From: Michael Eastham
Sent: 10 August 2018 14:46
To: Planning.Responses
Subject: FW: A/99/17/OUT - Landscape impact land South of Water Lane

From: Rita Williams [REDACTED]
Sent: 10 August 2018 14:36
To: Planning; Michael Eastham
Cc: Cllr. Dudley Wensley; Cllr. Andy Cooper; Cllr. Paul Bicknell; 'Deborah Urquhart'
Subject: A/99/17/OUT - Landscape impact land South of Water Lane

Landscape Impact and Mitigation

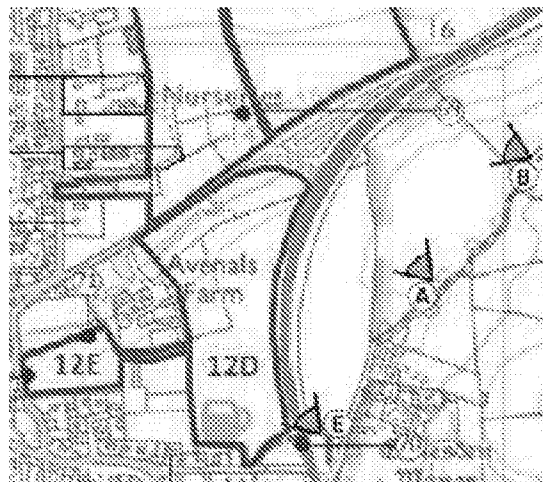
The applicant has submitted a revised "indicative plan" layout that adds a line of trees to the boundary and concedes that *"The exact composition of the mitigation planting would be the subject of a condition, but it is anticipated to be a belt of woodland comprising locally native broadleaved species."*

This appears to address Arun's Greenspace officer's concerns and would require a full landscape scheme to be submitted for approval, detailing species choice, position, densities and size at time of planting so that a clear picture of the proposals can be seen. These details are required to assure the adjacent landscape setting of the national park is maintained, the setting is uncompromised and the proposals are appropriate to their setting. However, the LVIA but is still missing the most important evidence i.e. that the effectiveness of the landscape screening both in summer and wintertime.

Assuming this *"belt of woodland"* reflects trees in the surrounding landscape (beech, ash, evergreen oak etc.) retaining the proposed **5m to 9m strip** is clearly not sufficient to allow these woodland trees reach maturity or to address issues of shading, the temptation to prune back branches, leaf fall etc.

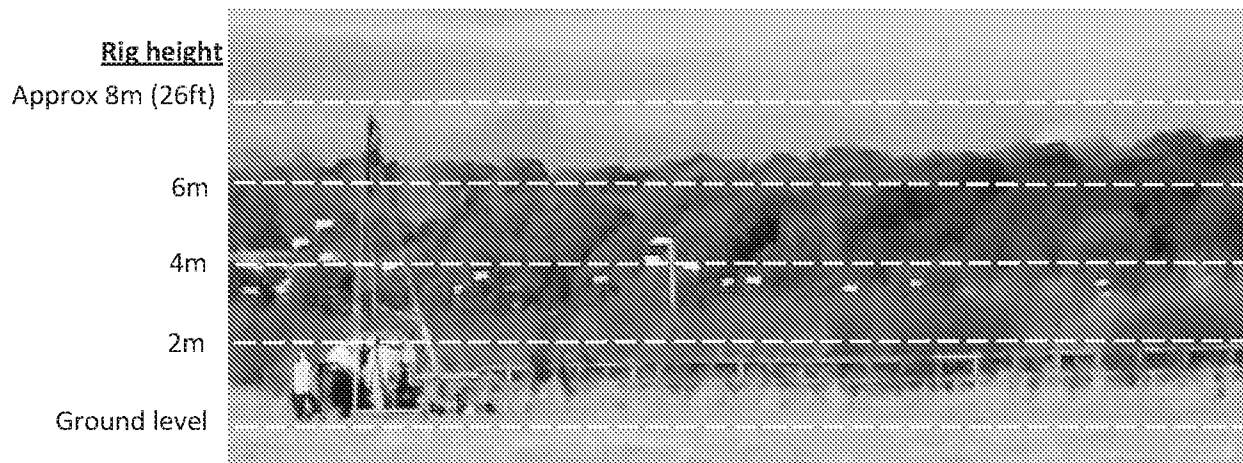
Photographs of the drilling rig erected at site 12D on 3rd November 2016 were submitted to examination. The rig height gives a useful and tangible reference point against which the proposed ridge heights of the development, between 10m and 12m, can be assessed.

The image below show both the approximate height of the drilling rig, calculated using the operative stood on the ground to the left of the rig.

PESP6: View E – from Ecclesden Lane east of A280 Footbridge

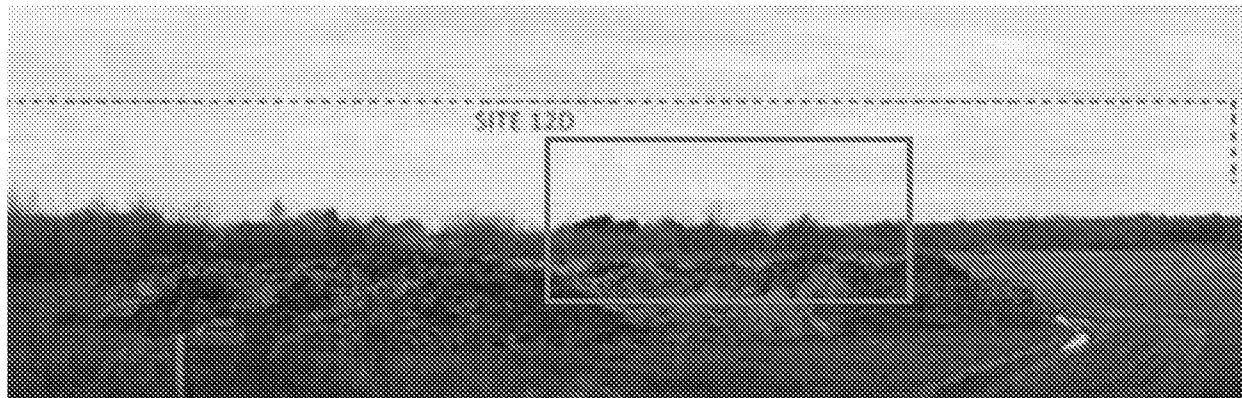
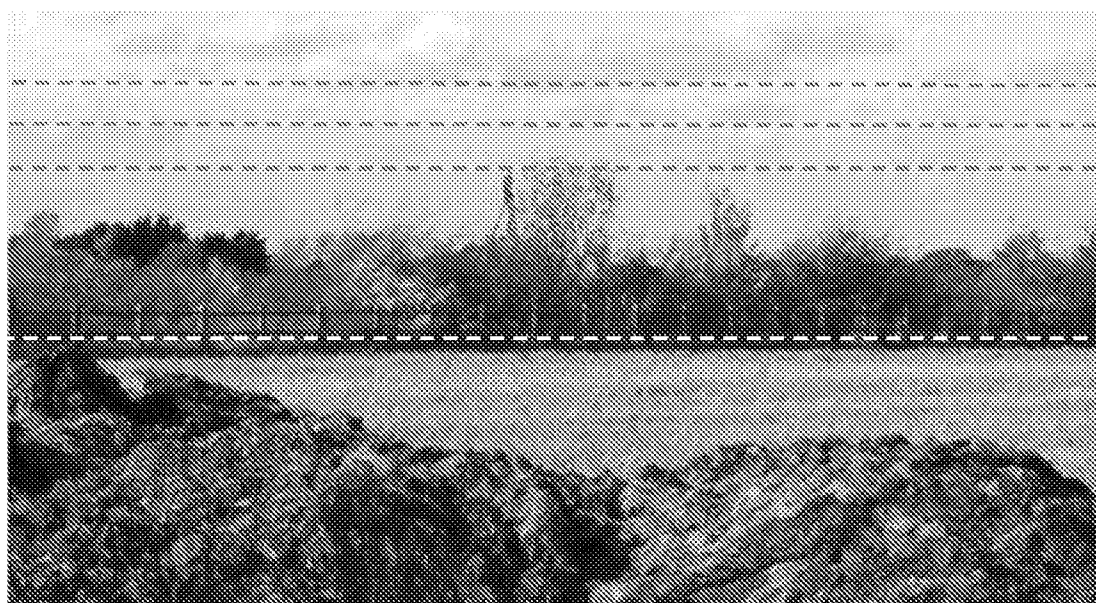
PESP6 was submitted by Arun to examination and **included a viewpoint assessment** of site 12D, Land south of Water Lane intended to help demonstrate the visual effects from within the SDNPA from the lower lying ground east of the A280. It concludes that some rooftops would be visible from Footpath 2148 (viewpoints E, A and B) and that a generous planted mitigation buffer is required to address this issue.

Photo of drilling rig from the gate, the site is approx 100m from this point.

PESP6: View A– from footpath 2148 North of Ecclesden Manor

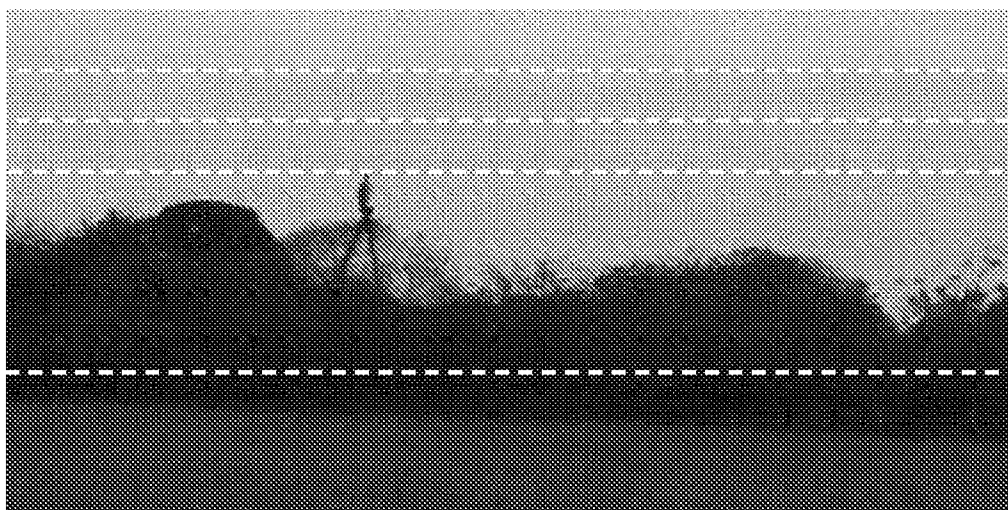
Photo of drilling rig from footpath, the site is less than 200m from this point.

Mock-up shows extent of development that will be “glimpsed” over existing landscape buffer.
